1. PCI Engineering Change Notice – Addition of the SMBus to the PCI Connector

TITLE:	Addition of the SMBus to the PCI Connector
DATE:	October 5, 2000
AFFECTED DOCUMENT(S):	PCI Local Bus Specification, Revision 2.2, December 18, 1998
SPONSOR:	Chuck Stancil, Compaq Computer Corporation Michael Smith, Gateway Corporation Steve Williams, Intel Corporation

Figure 8-1. ?????????

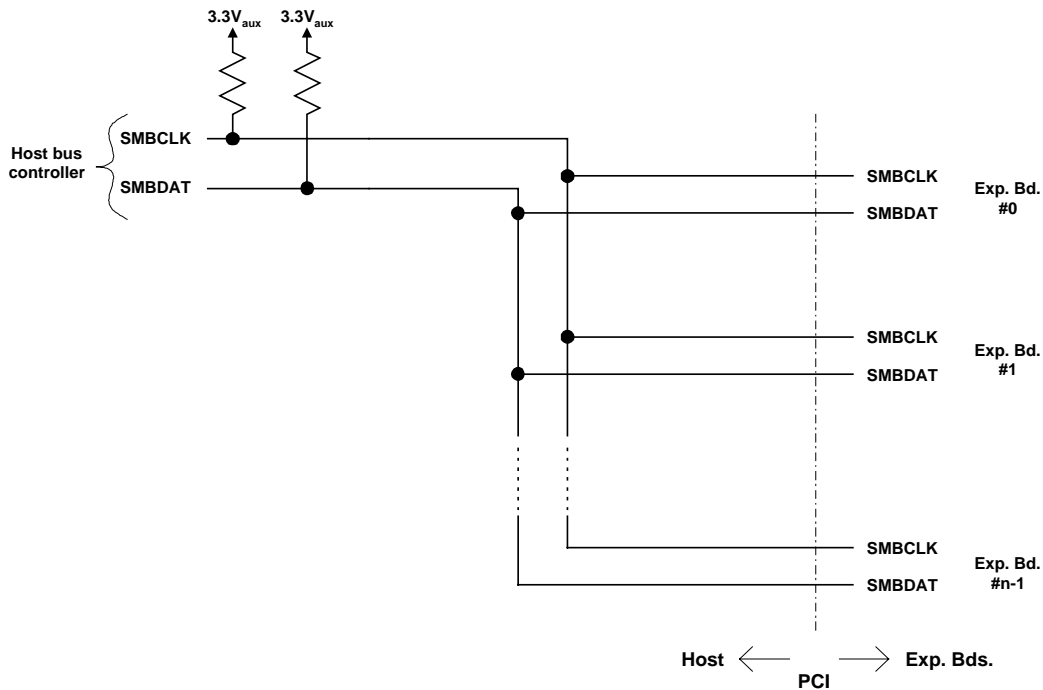
Connection of SMBus to expansion slots is optional. However, if SMBus is connected to one slot in a chassis, it must be connected to all slots in that chassis. SMBus-connected slots in a chassis must be in the same logical SMBus. This logical SMBus may optionally be broken during system initialization or hot remove to allow the system to determine which SMBus device is in which PCI slot, but must be restored before the end of system initialization and during normal operation.

A typical implementation of a single physical SMBus is illustrated in the diagram below. The SMBus host bus controller is provided by the system.
